SAN FRANCISCO PLANNING DEPARTMENT

Discretionary Review/Variance Full Analysis

Date: September 8, 2015
Case No.: 2015-001277DRP-VAR
Project Address: 3772 20th Street
Permit Application: 2015.06.16.9131
Zoning: RH-3 (Residential House, Three-Family)
40-X Height and Bulk District
Block/Lot: 3598/138
Project Sponsor: C. Steven Swason
12800 Shenandoah Road
Plymouth, CA 95669
Staff Contact: Todd Kennedy – (415) 575-9125
todd.kennedy@sfgov.org
Recommendation: **Do not take DR and approve the project as proposed**

20th ST
SITE PLAN - PROPOSED
1/8" = 1'-0"

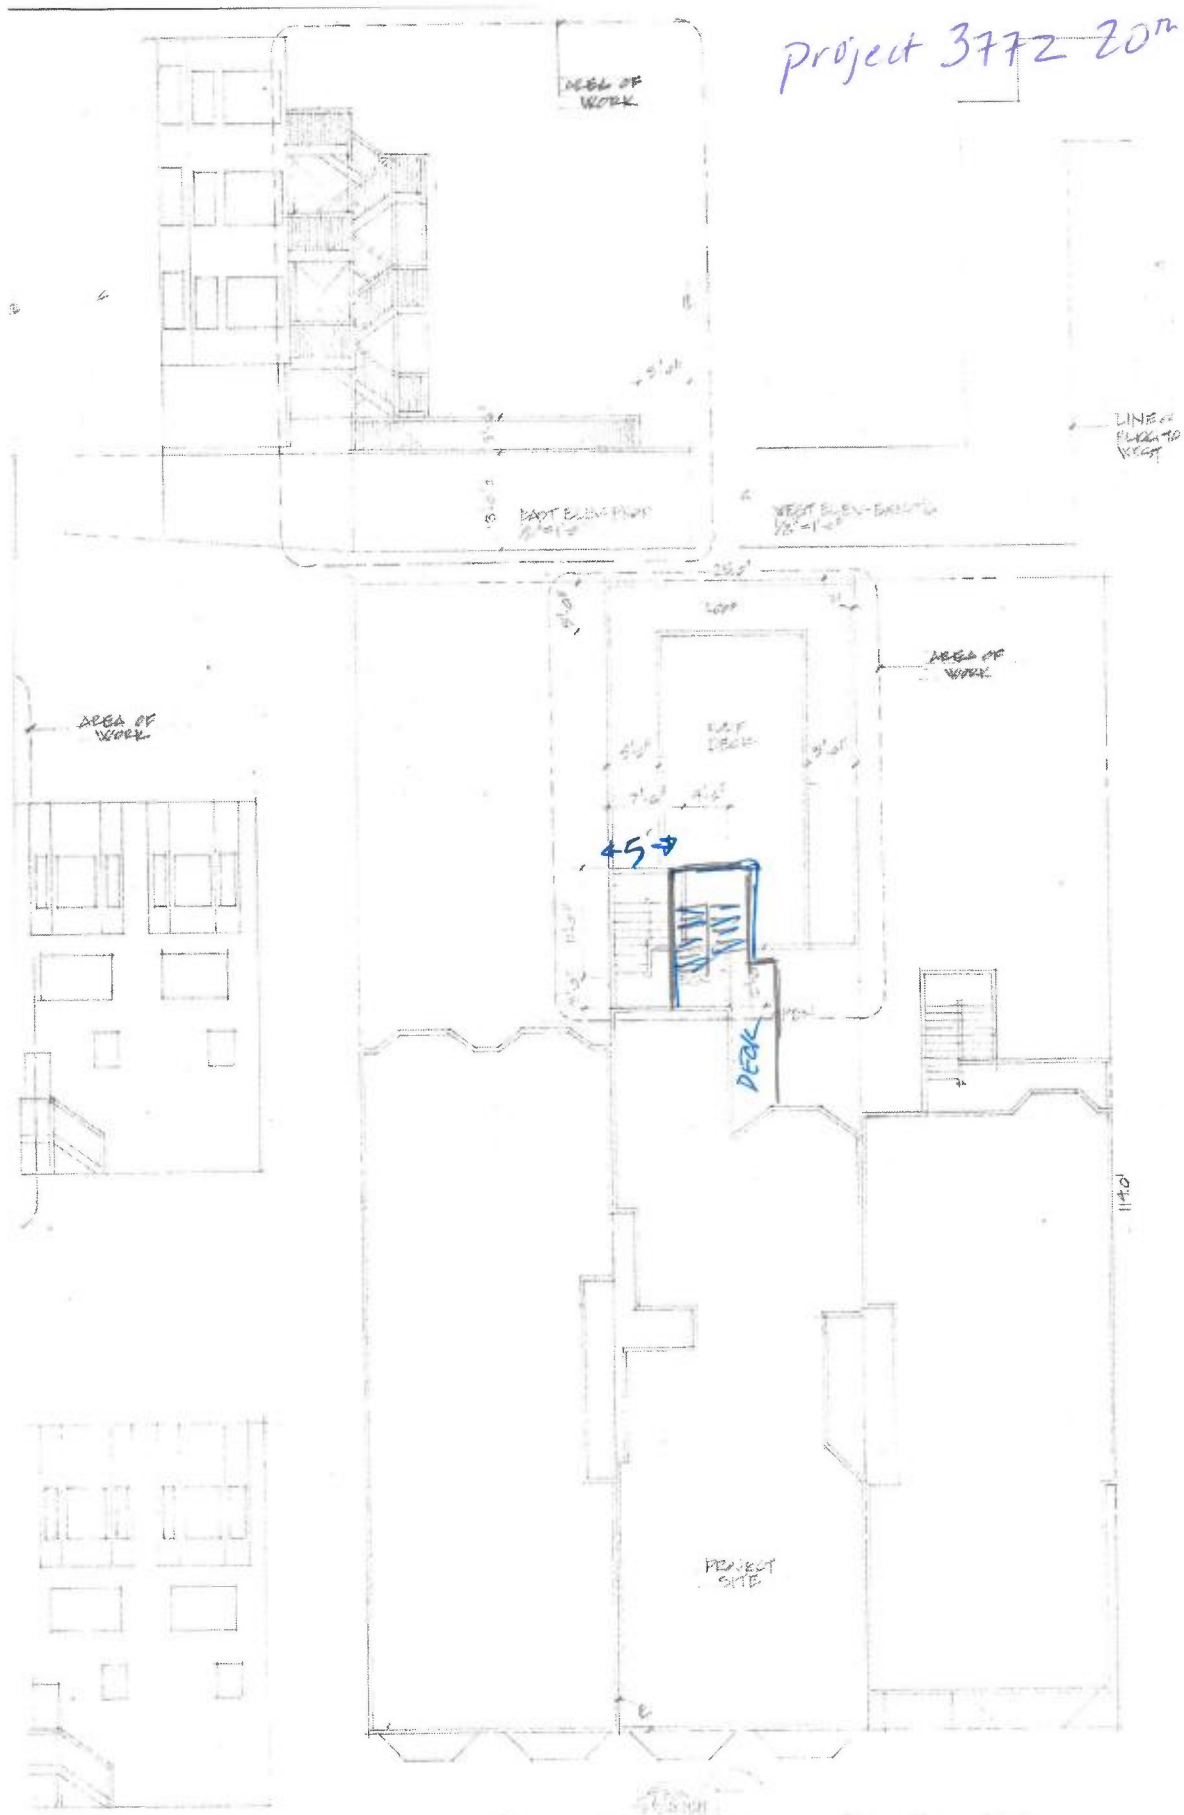
POSSIBLE ALTERNATE DESIGN
WITH STAIRS MOVED 5' OFF PROPERTY LINE, AS WAS
DONE FOR #3766-3768

Issue 3: Following the filing of the Discretionary Review, the project sponsor has made changes to the plans that meet the DR Requestor's concerns. The plans were revised so the proposed stairway is setback 5 feet away from the side property line. Therefore, no firewall extension is necessary. Also, the garage roof will be lowered and the deck will be setback 5 feet on all property lines. Therefore, the project meets the DR Requestor's concerns.

Project
3772 20th St

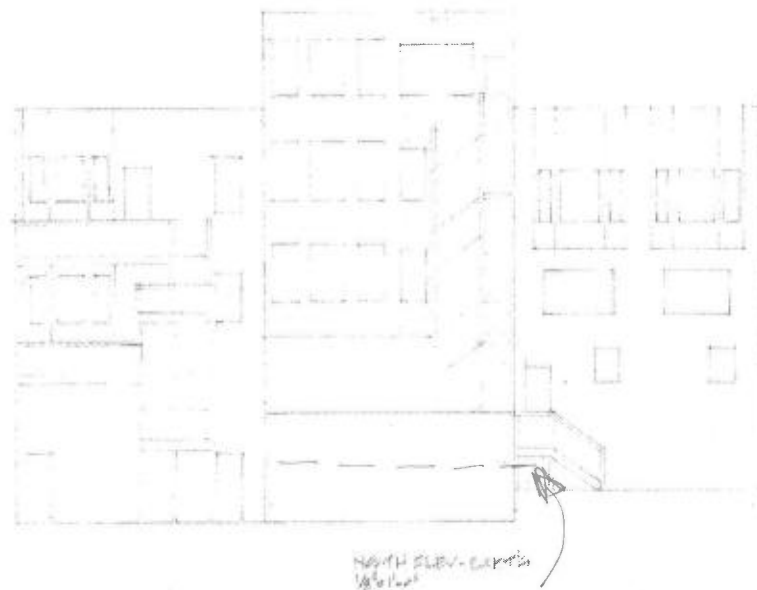
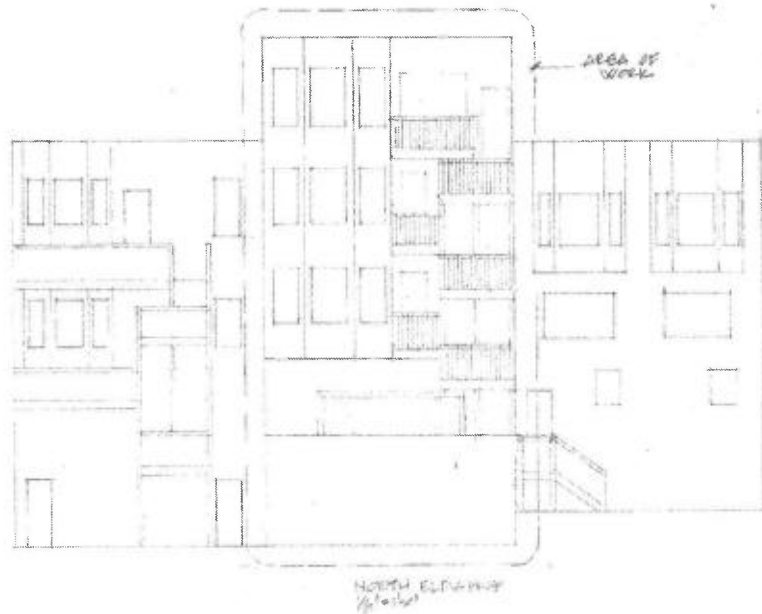
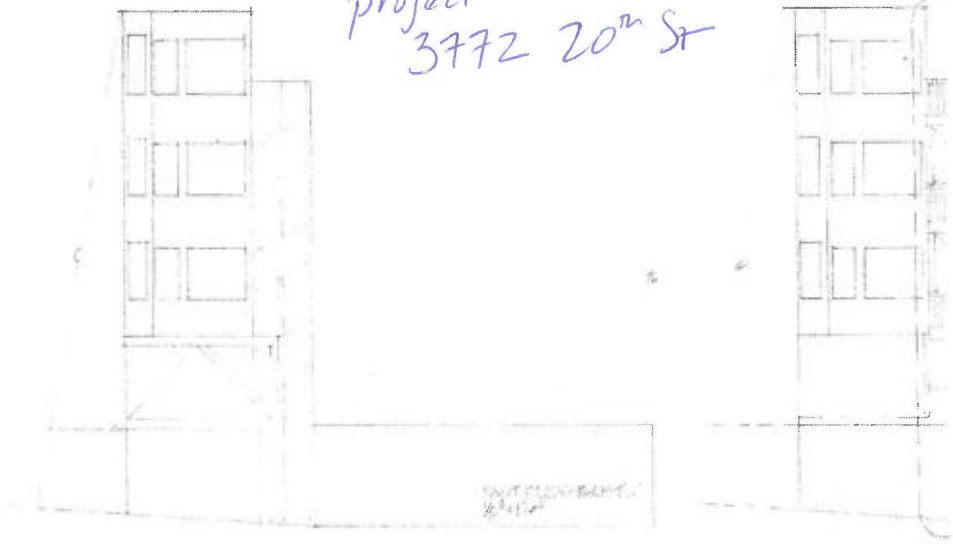
THIS IS NOT AN
ACCURATE
DRAWING OF
EXISTING
STRUCTURE.
ROOF LINE IS
BELOW THE
LANDING FOR
ADJACENT STAIR

THE CURRENT ROOFLINE IS BELOW THE
LANDING. IT IS HIGHER AT THE NORTH
END OF THE PROPERTY, BUT THIS
DRAWING IS MISLEADING.

This project proposes an improvement to this rear building, which will improve its integrity and enhance its quality and aesthetics. The Project Sponsor rechecked the roof height and determined it was incorrectly drawn on the plans. He has made plan corrections and is proposing to lower the roof height to 8 feet.
